Board of Zoning Adjustment

Staff Report

Case No:	18VARIANCE1013
Project Name:	Old Forester Distillery Signage
Location:	117 W Main Street
Owner(s):	Brown Forman Corporation
Applicant:	Kyle Hatfield – Nimlok Kentucky
Jurisdiction:	Louisville Metro
Council District:	4 – Barbara Sexton Smith
Case Manager:	Dante St. Germain, Planner I

4. Elevations

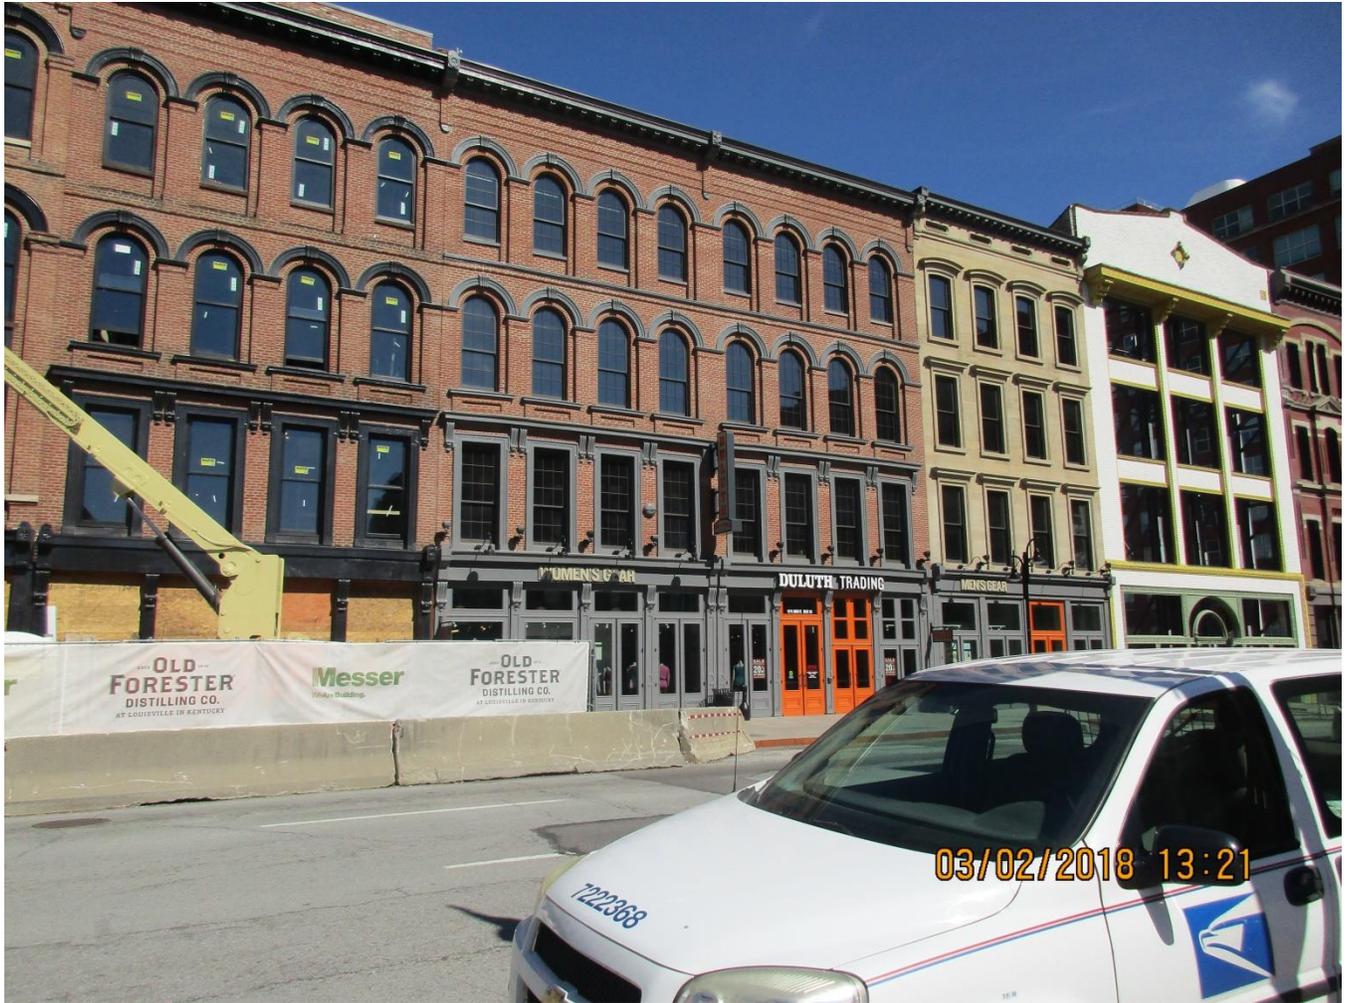
Land Development Code table 8.3.2 Downtown states the allowable signage for a property in the Downtown form district. For this property, the allowable area for all signs on the Main Street façade is 300 sf. The applicant proposes a total of 9 signs on the façade with a combined area of 325.67 sf. The applicant therefore requests a variance for the area of signage that exceeds the allowance.

Table 8.3.2 also states that for single-tenant buildings, the maximum number of attached signs allowed is 3 per façade. Because the applicant proposes 9 signs in total, a waiver is requested from this limitation.

STAFF: The requested variance will not cause a hazard or nuisance to the public as the signs are proposed to be muted colors with minimal lighting, which will not create a hazard to drivers or pedestrians. The largest sign is proposed to be painted onto the façade.

- 1. The painted signs should not appear “weathered” like on the drawings. The painted signs should be clean, crisp, and of their time in order to not create a false historicism.**
- 2. If the design or materials change, the applicant shall contact staff for review and approval.**
- 3. The applicant, owner, and/or their representative shall obtain the necessary approvals from other Louisville Metro Government agencies and departments.**
